Planning Commission agenda report for June 28, 2023: Preliminary Plat for Crimson Peaks subdivision.

Acres: 176 acres this Preliminary Plat

Project location: South side of Hwy 59 between Crimson Parkway and Gooseberry Way

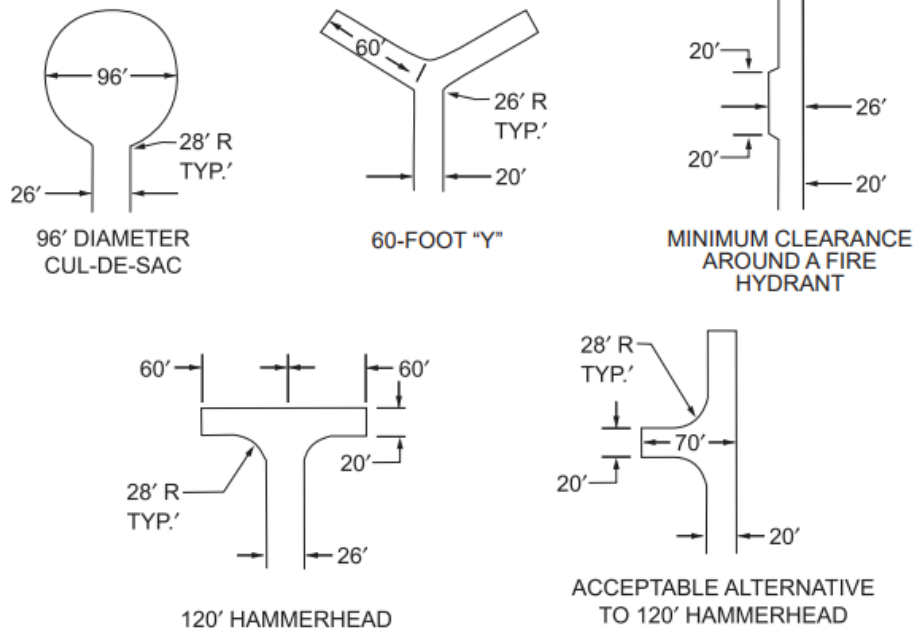
Preliminary plat: The plat contains 262 lots located on the south side of Hwy 59 and generally between Crimson Parkway and Gooseberry Way. The subdivision area is zoned SF-.50 with minimum lots size in this zone is 20,000 square feet. The preliminary plat shows compliance with these minimum lot sizes subject to approval of a pending zone change for 12.47 acres, requesting SF-.50 zoning. The proposed subdivision is laid out in a grid pattern with square blocks and public streets. There are no hills, springs or seeps located on the property according to the plat submittal information.

Staff Comments: Preliminary Plat is ready for approval subject to approval of a zone change on 12.47 acres located in a portion of the proposed subdivision, and also subject to approval of a wastewater disposal plan by Ash Creek SS District. The present water commitment is for only 31 lots, and not for the entire project of 262 lots. The applicant should work with both the Ash Creek SSD and the Big Plains Water SSD to obtain approvals for the water and sewer service for the entire proposed project.

Fire comments: Dead-end fire apparatus access roads in excess of 150 feet shall have an approved turnaround as indicated below. Dead-end apparatus access roads, during phased development shall have approved turnarounds if longer than 150 feet. (2018 IFC 503.2.5)

Show all turning radius are a minimum of 35 feet inside and 55 feet outside face of curb. (2018 IFC 503.2.4)

Fire apparatus access roads shall support a gw of 85,000 lbs. Apparatus access roads shall be all weather surface. (2018 IFC 503.2.3)

Water/utility development plans shall show fire hydrant locations.
